Access Compliance Report

Public Rights-of-Way

(Pedestrian Signals)

Intersection ID: N/A	Main Street:	Cross Street: N/A	Location: N/A
ADA ID: EF9A14B3CE42	Signal Type: One Push Button-Non APS	Overall Compliance: No	Severity Score: BTN 1: N/A BTN 2: N/A No BTN: N/A
Codes/Mitigation Info/Possible Solution		Field Measurements/Component Compliance

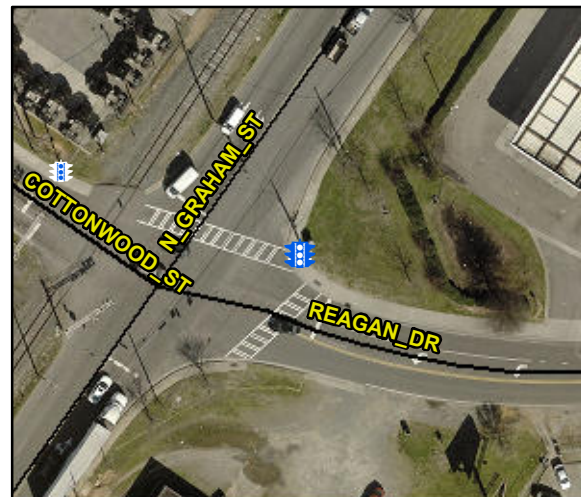
Surveyor Notes: TEXT HT 5/16

PROW/ADA: R410.6, R209.1, TMUTCD 4e.08, R404.2, R406.2

Yes	B 1 Clear Xing Direction?	ClearlyMarked	N/A	B 2 Clear Xing Direction?	N/A
	B 1 Crossing Direction	To W		B 2 Crossing Direction	N/A
Yes	B 1 DistanceTo XWalk (in)	28.0	N/A	B 2 DistanceTo XWalk (in)	N/A
No	B 1 DistanceTo Curb (in)	80.0	N/A	B 2 DistanceTo Curb (in)	N/A
Yes	B 1 Diameter (in)	2.0	N/A	B 2 Diameter (in)	N/A

Possible Solutions: Replace Signal Push Button With APS Button on New Post. Remove & Replace Sign.
